HISTORIC AND DESIGN REVIEW COMMISSION

HDRC CASE NO: 2019-287
ADDRESS: 151 E TRAVIS ST
LEGAL DESCRIPTION: NCB 403 BLK 14 LOT W IRR 148 OF 8 & 9 ARB AB9
ZONING: D, HS
CITY COUNCIL DIST.: 1
LANDMARK: Travis Building
APPLICANT: Kris Feldman/CreoArc
OWNER: IconicOZ Artista Fund, LLC
TYPE OF WORK: Construction of an 8-story hotel
APPLICATION RECEIVED: May 20, 2019
60-DAY REVIEW: July 19, 2019
CASE MANAGER: Edward Hall
REQUEST:

The applicant is requesting conceptual approval to construct an eight story hotel structure on the vacant lot at 151 E Travis Street. The proposed new construction is to feature 112 hotel rooms, with both street and river level retail space.

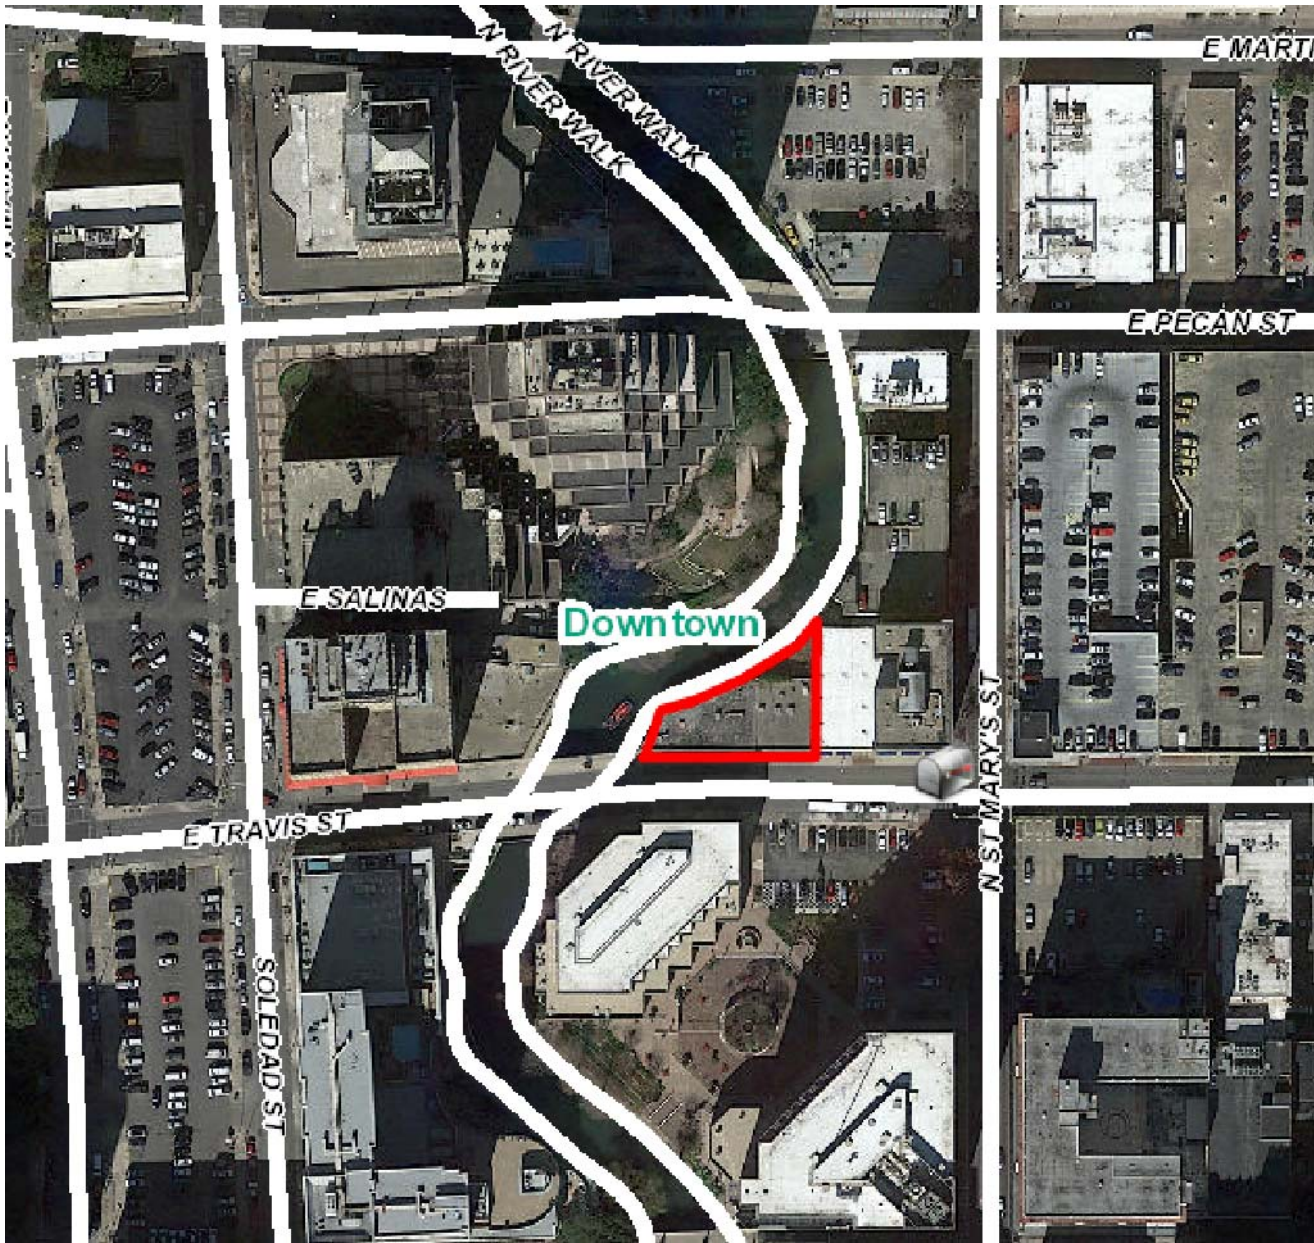
- j. **CANTILEVER** – The applicant has proposed a cantilever over the public right of way at the River Walk level. The proposed cantilever will extend over landscaped areas at the River Walk level as well as portions of the pedestrian pathway. The UDC Section 35-672(a)(2) notes that no structure, building, roof or skywalk may be constructed over the river or creek channel, or by-pass channel with the exception of structures for flood control purposes, open air pedestrian bridges at ground or river level, and street bridges. The river channel is the natural course of the river as modified for flood control purposes and the Pershing-Catalpa ditch. Staff is concerned

regarding the proposed cantilever over the River Walk level and finds that the applicant should explore ways to mitigate or reduce the impact of the proposed cantilever.

- i. That the applicant explore ways to reduce the impact or eliminate the cantilever over the River Walk area.
- ii. That fenestration and other façade separating elements be added to the south and east facades as noted in finding n.

SOLAR STUDIES - (CURRENT)

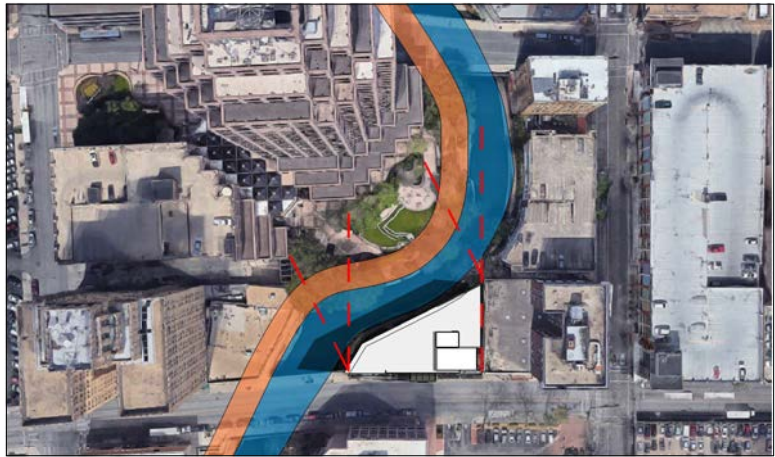
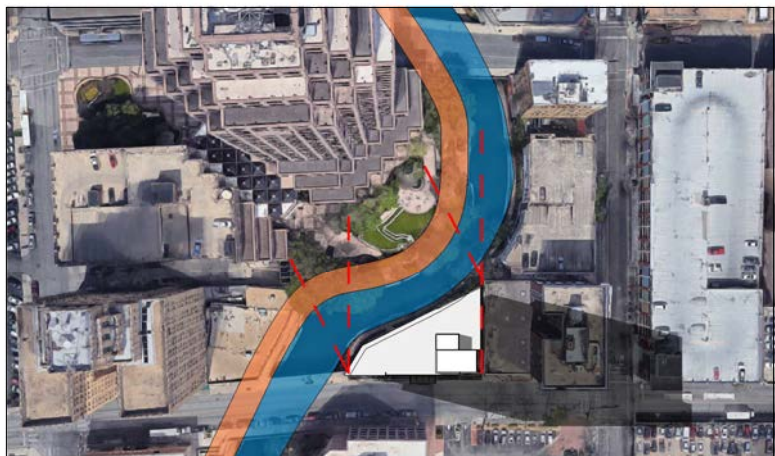
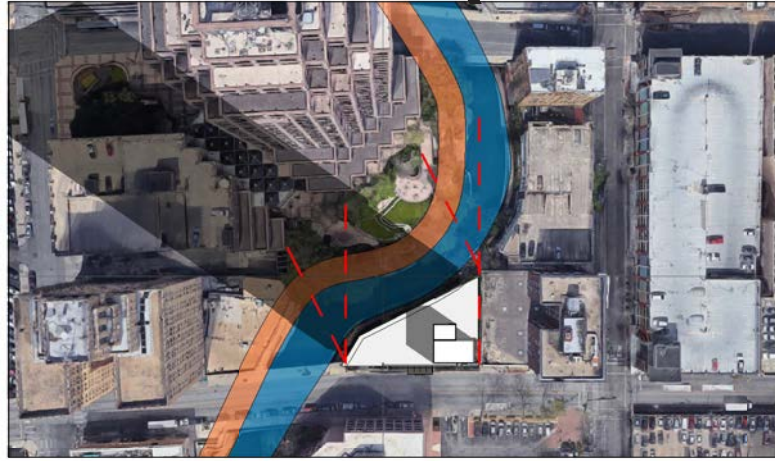
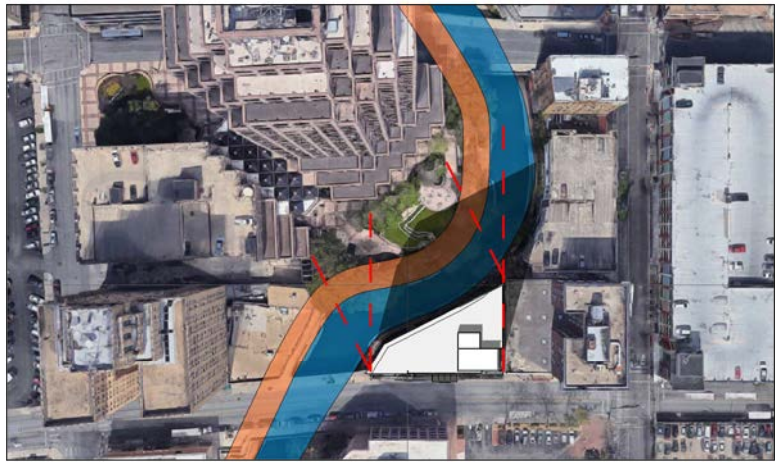
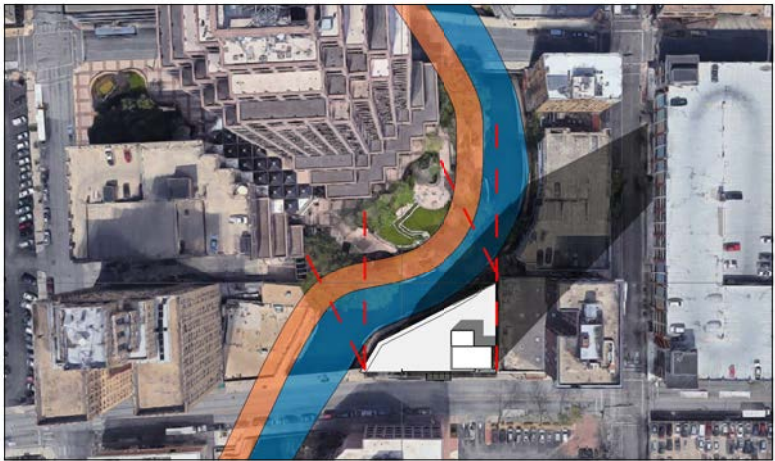
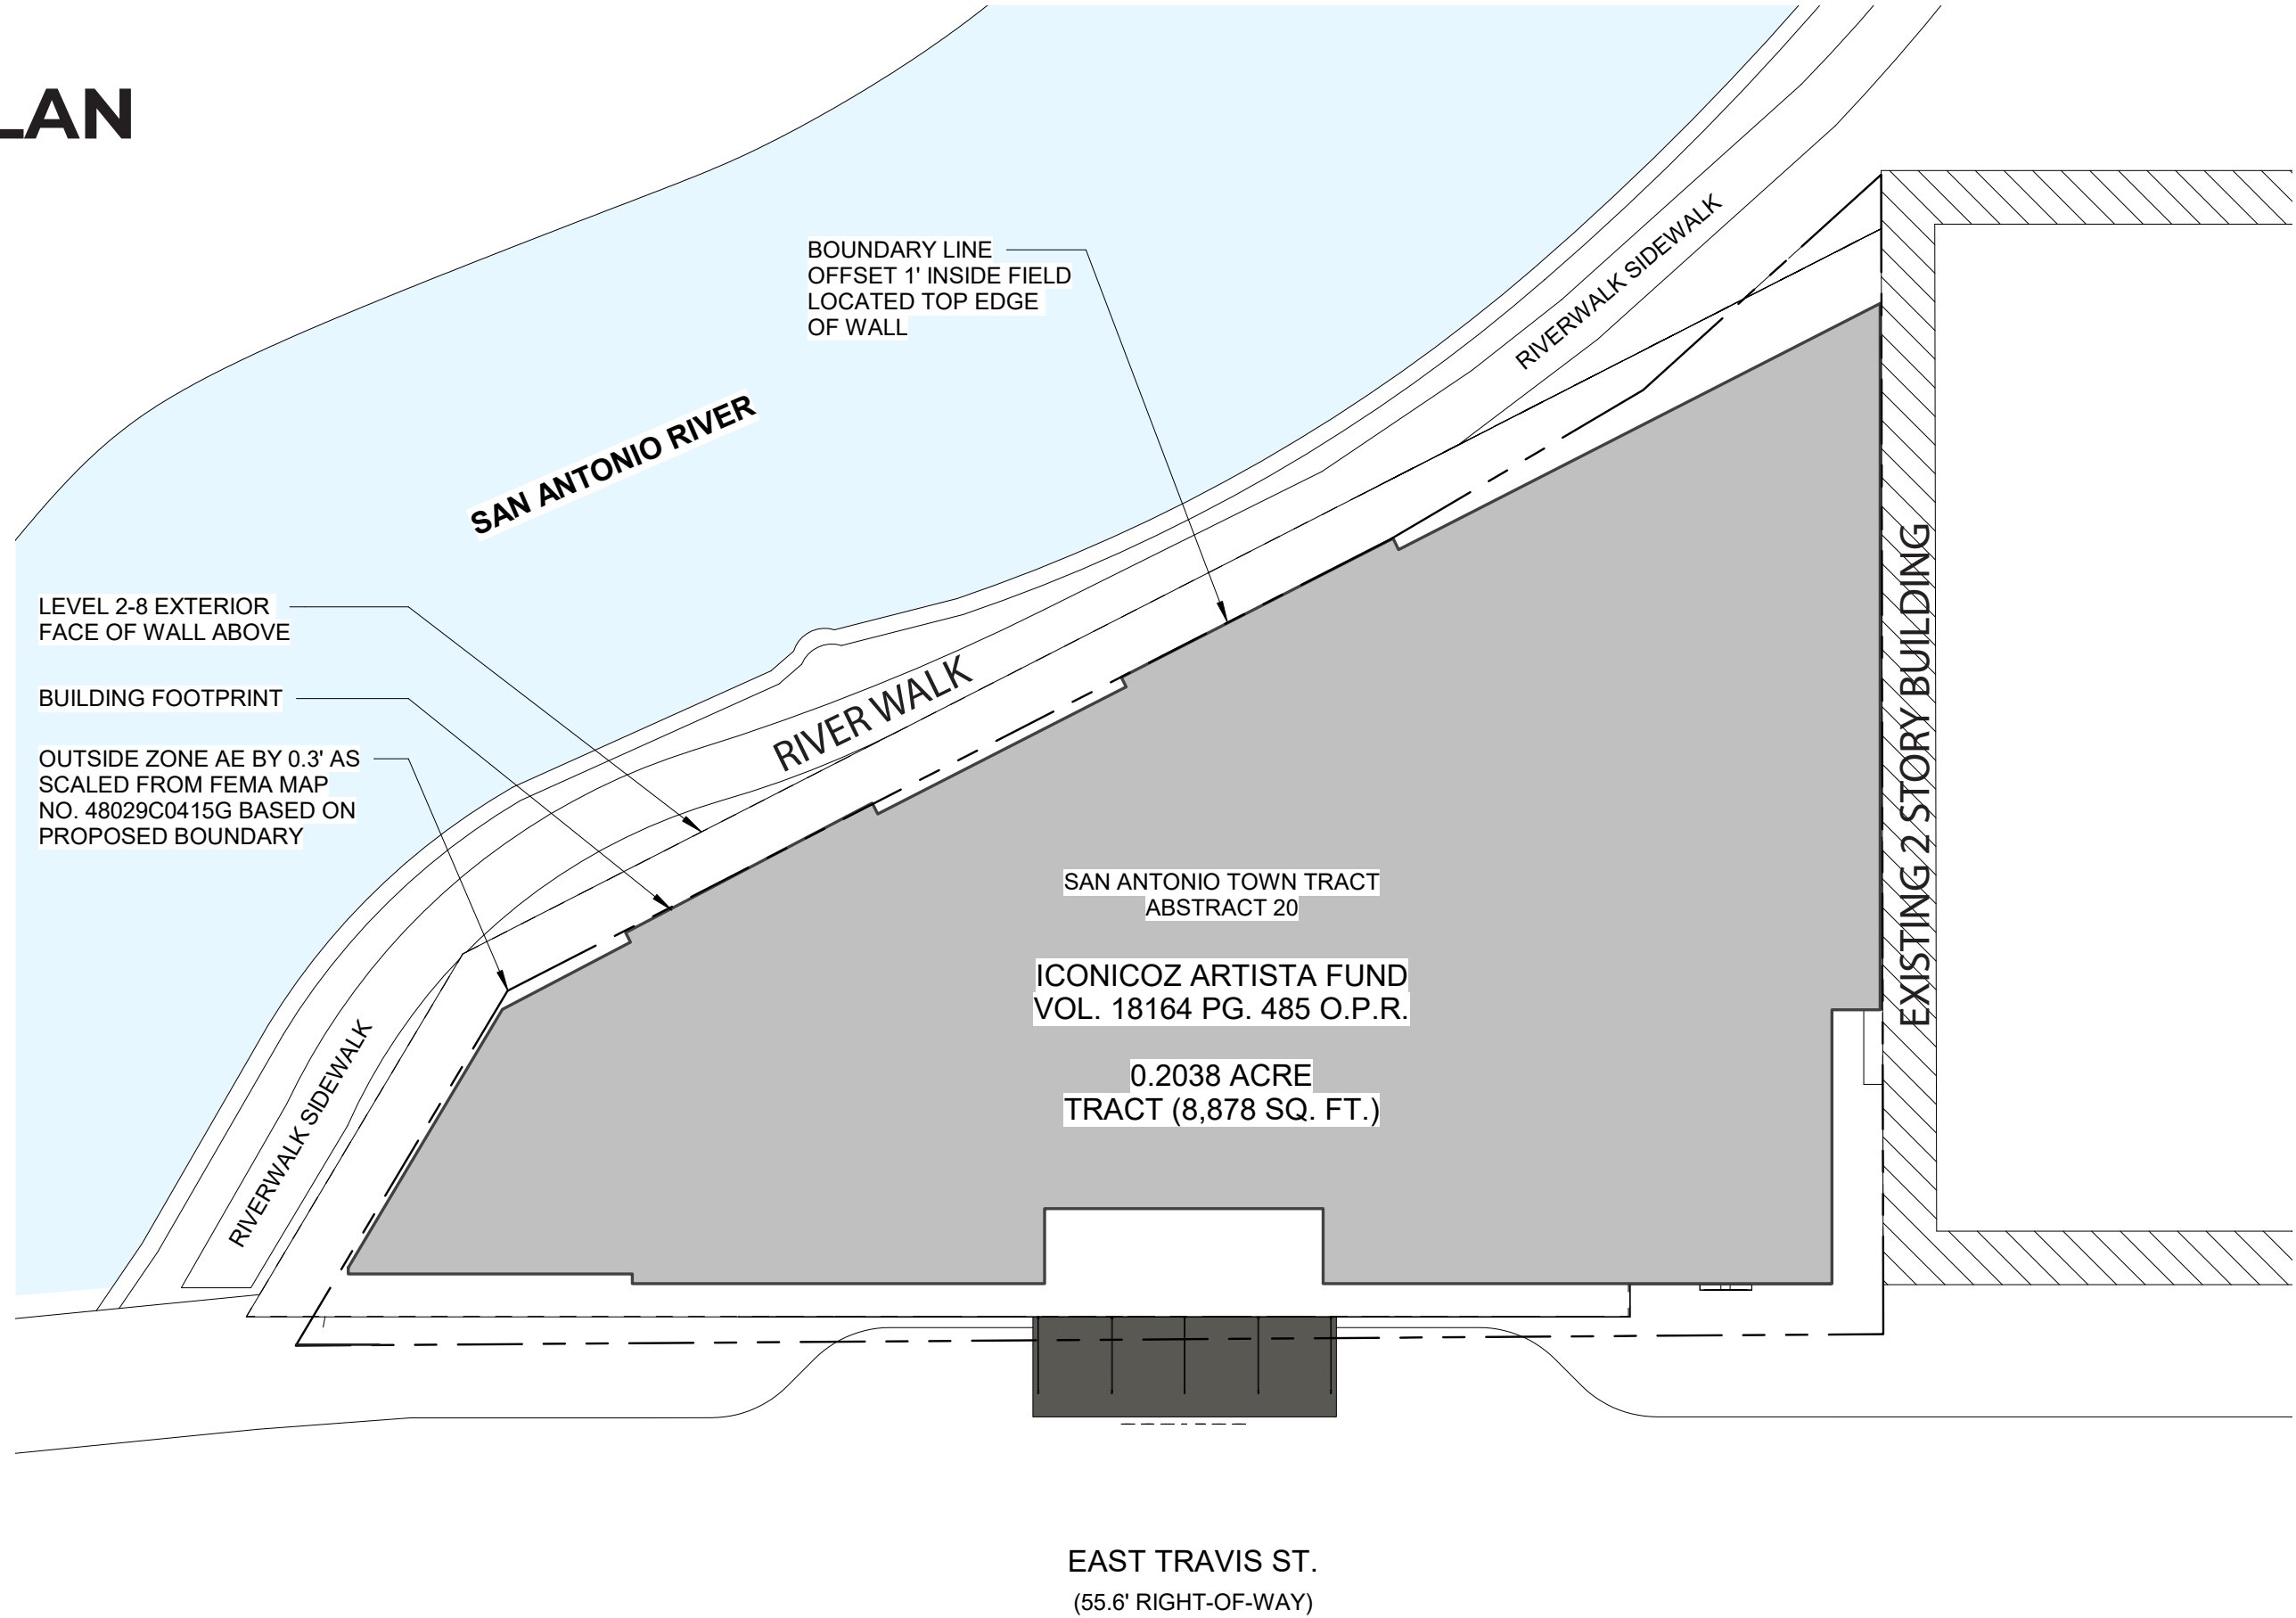
- k. **BUILDING HEIGHT & SCALE (Solar Study)**– According to the UDC Section 35-674(c) in regards to the height of new construction in RIO districts, there is no maximum height of new construction in RIO-3 provided that solar access standards are met. 5.5 hours of direct sunlight are required during the winter solstice and 7.5 hours of direct sunlight are required during the summer solstice. The applicant has proposed a solar study which notes that the UDC requirements have been met.
